# *Addendum*

| **Project Name** | Dexter Community Schools – Dexter High School New Field House |
| **Design Release No.** | Two (2) |
| **Addendum No.** | One (1) |

**S1.0A**

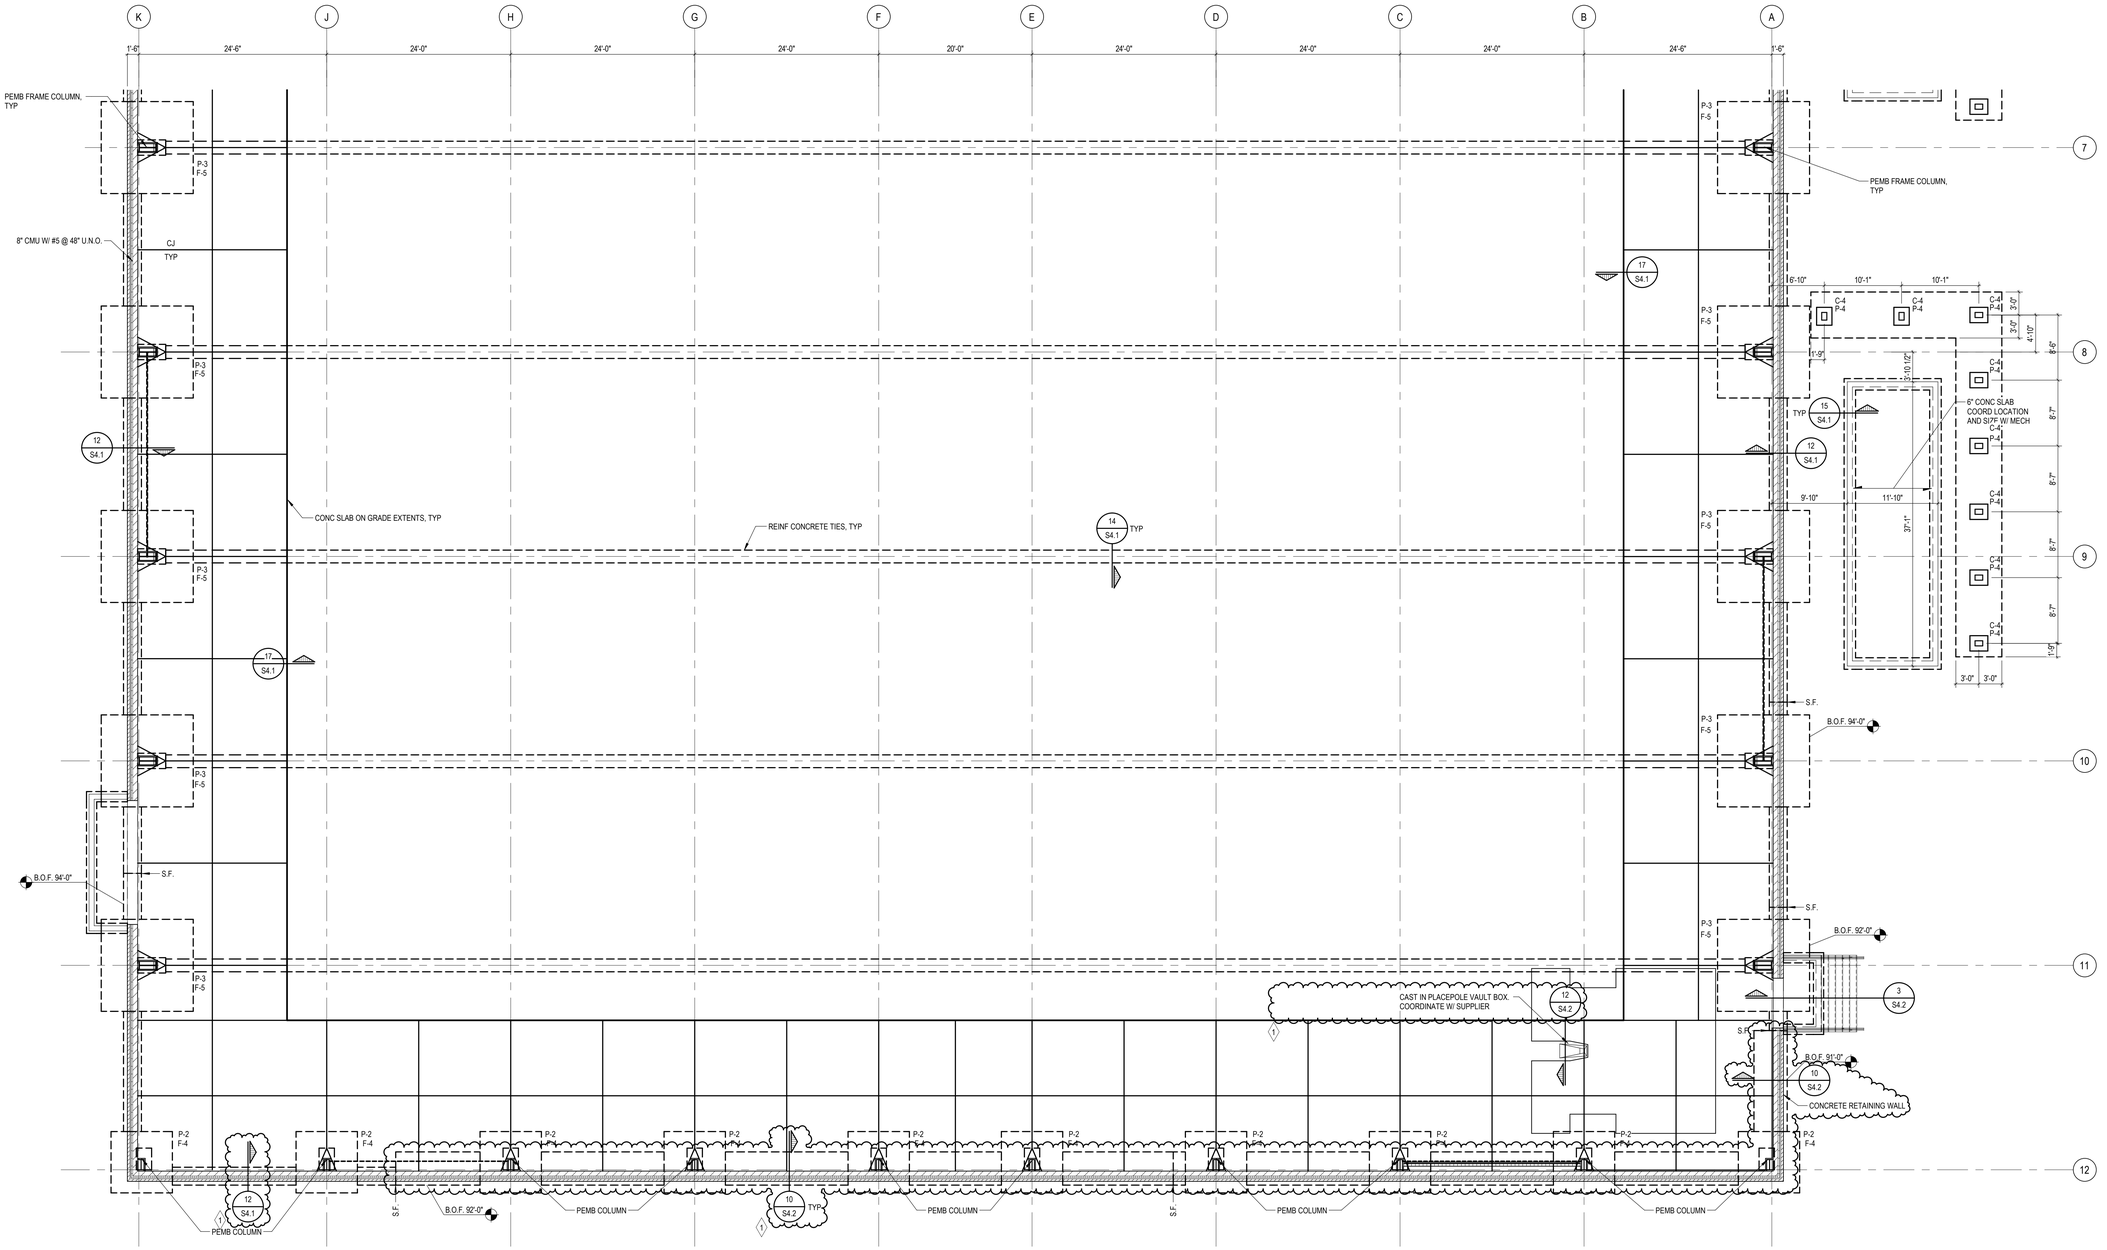
| **Item No.** | **Structural Drawing Changes** |
|---|---|
| SD-1 | Refer to Drawing No. S1.0A (reissued):<br>A. Deleted Detail cut 1/S4.2 as indicated.<br>B. Added Detail cut 11/S4.2 as indicated.<br>C. Revised footing elevations as indicated.<br>D. Revised stoop slab sizes as indicated |

**S1.0B**

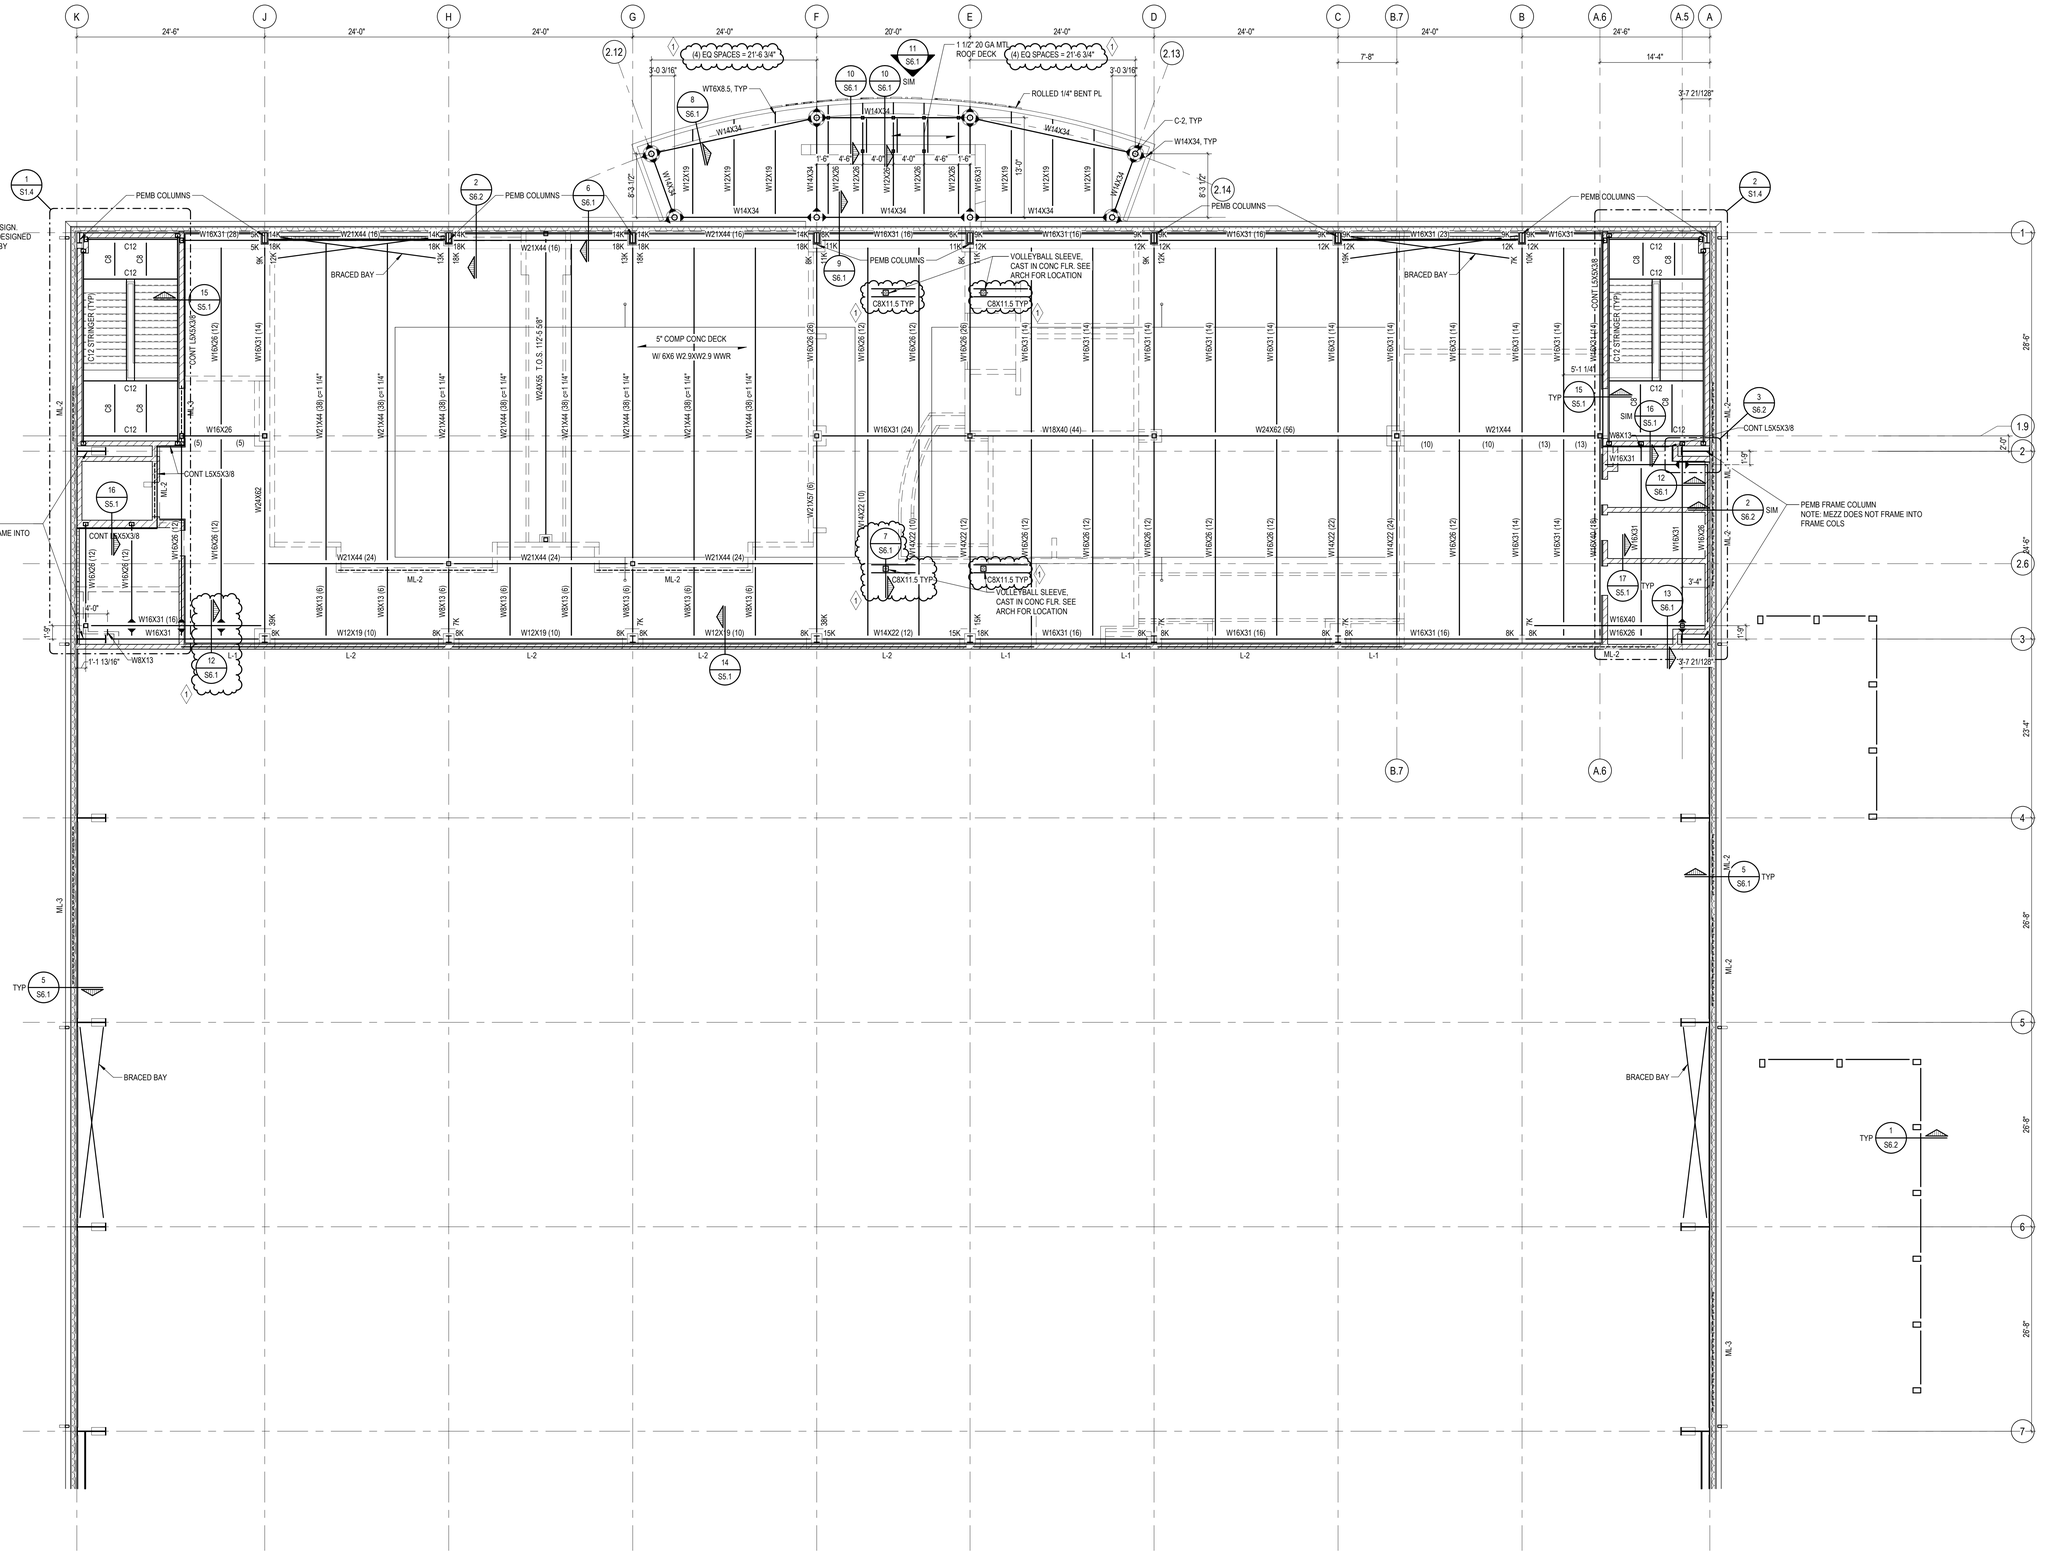
| **Item No.** | **Structural Drawing Changes** |
|---|---|
| SD-2 | Refer to Drawing No. S1.0B (reissued):<br>A. Revised Detail cut 12/S4.1 as indicated.<br>B. Added retaining wall as indicated.<br>C. Added Detail cut 10/S4.2 as indicated.<br>D. Added 12/S4.2 as indicated.<br>E. Revised pole vault note as indicated. |

DRAWING NO.
**S4.2**

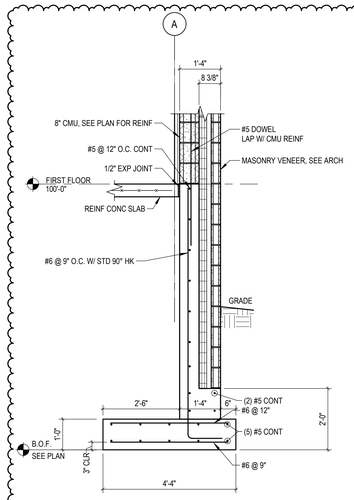
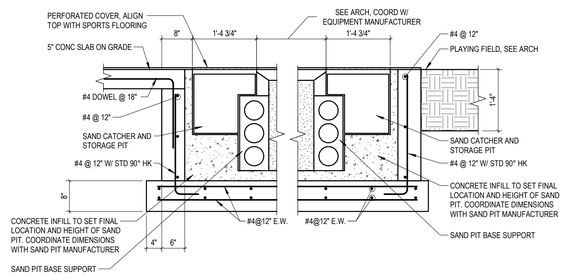
| **Item No.** | **Structural Drawing Changes** |
|---|---|
| SD-4 | Refer to Drawing No. S4.2 (reissued):<br>A. Refer to Detail 9. Revised top course to 12” CMU as indicated. Revised brick ledge dimension as indicated.<br>B. Added Details 10, 11, and 12 as indicated. |

DRAWING NO.
**S6.1**

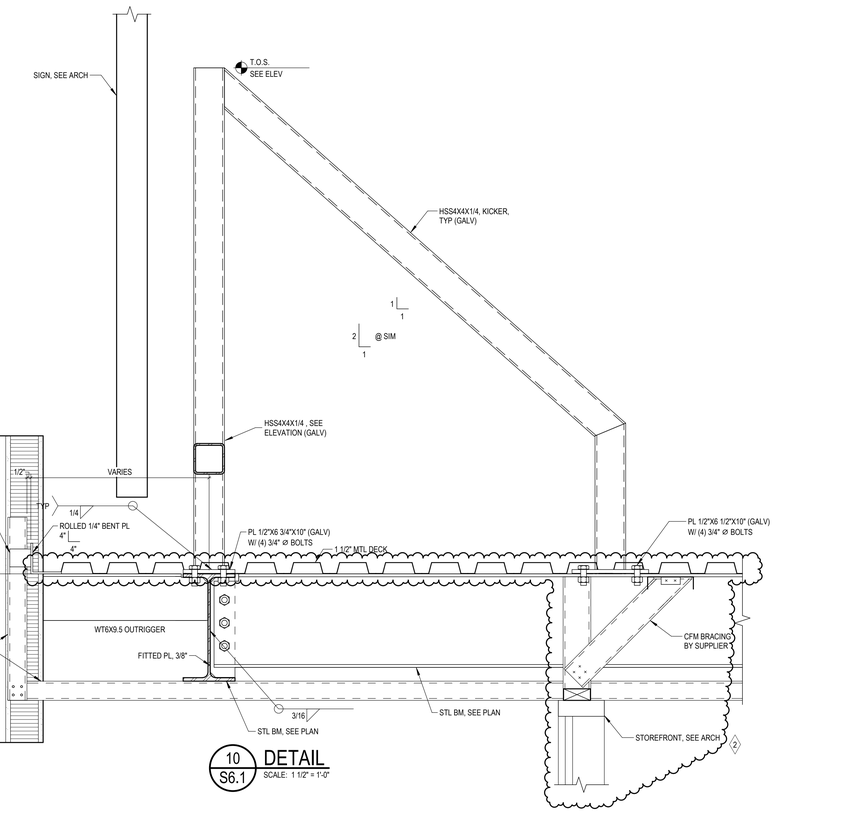
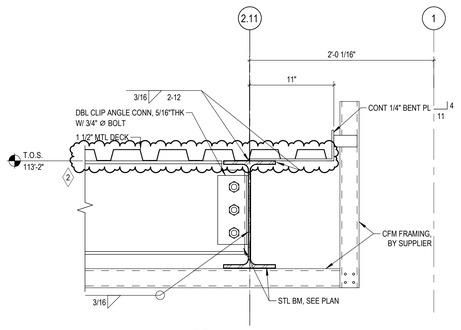
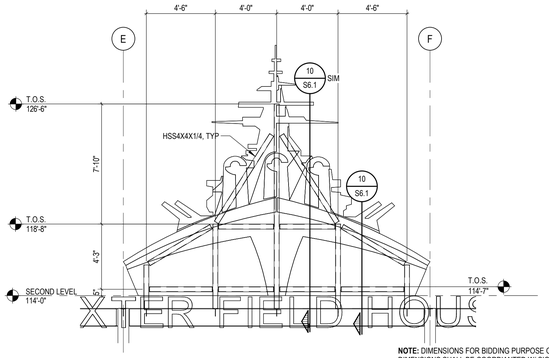
| **Item No.** | **Structural Drawing Changes** |
|---|---|
| SD-5 | Refer to Drawing No. S6.1 (reissued):<br>A. Deleted Detail 3/S6.1 as indicated.<br>B. Refer to Details 8 and 9, revised deck direction as indicated.<br>C. Revised Details 7 and 9 as indicated. |

AD.1

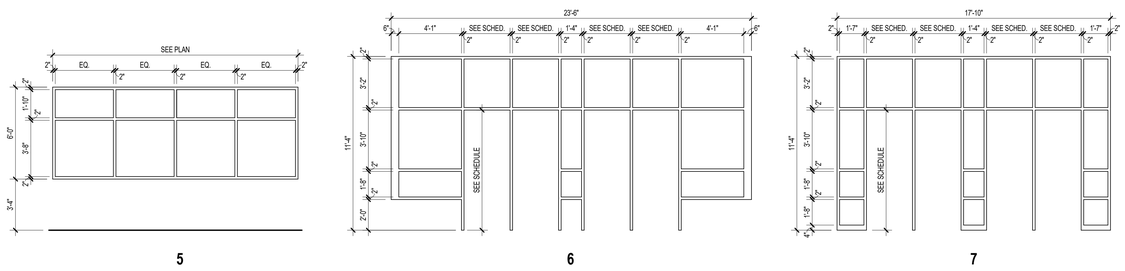
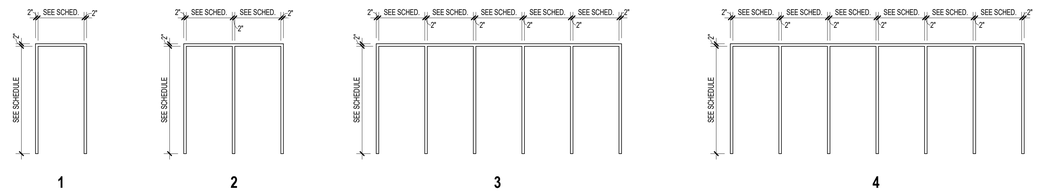
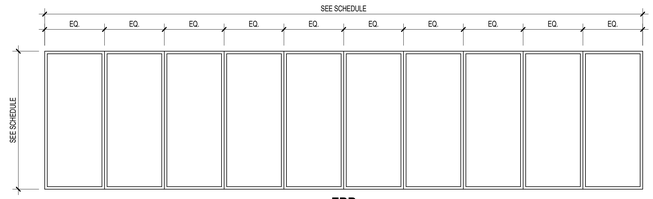
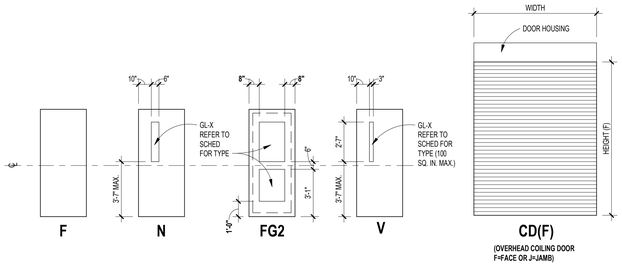
| Item No. | Architectural Drawing Changes |
|---|---|
| AD-1 | Refer to Drawing No. AD.1 (reissued):<br>A. Revised door hardware sets as indicated. |

DEXTER LOGO FLOOR PLAN

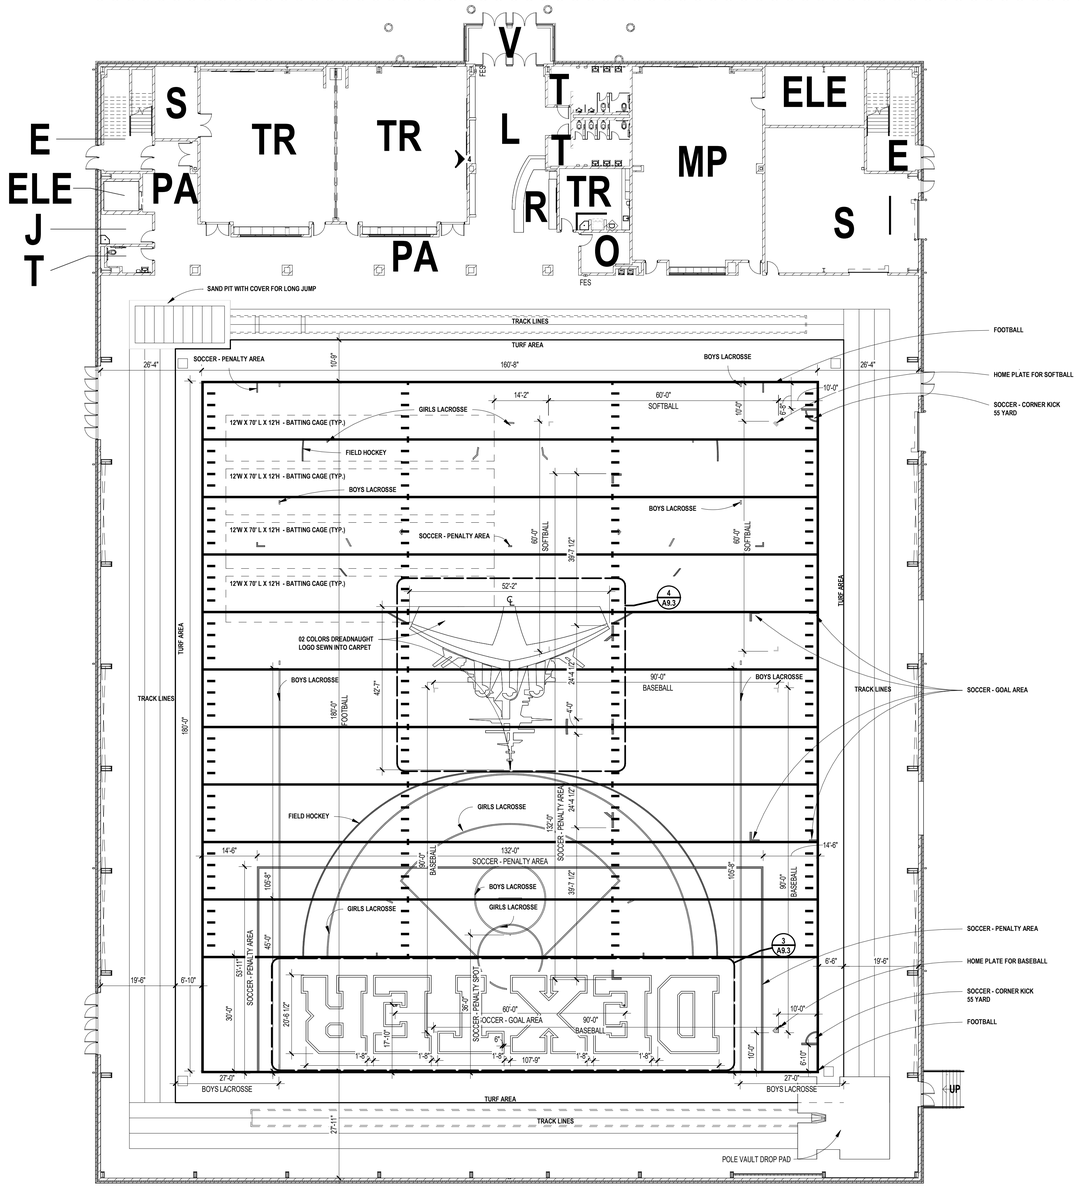
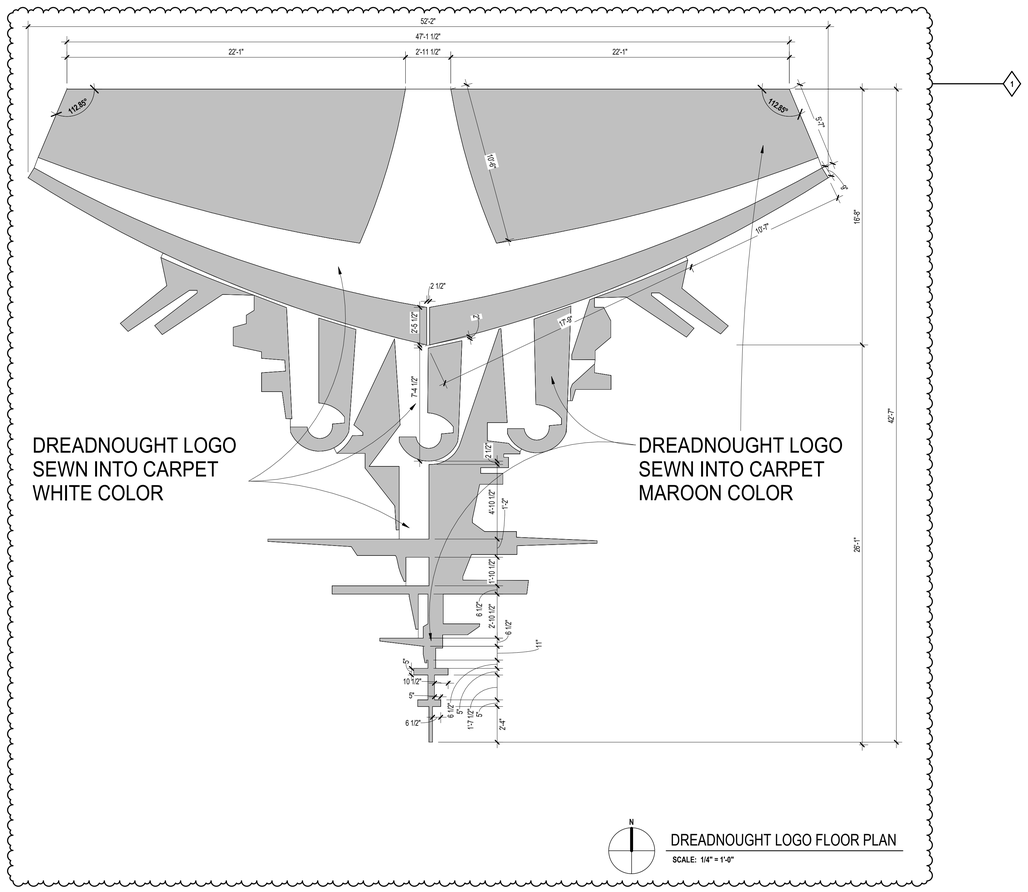
| Item No. | Architectural Drawing Changes |
|---|---|
| AD-5 | Refer to Drawing No. A9.3 (reissued):<br>A. Added Dreadnought Logo Floor Plan as indicated.<br>B. Added Dexter Logo Floor Plan as indicated.<br>C. Added general notes as indicated. |
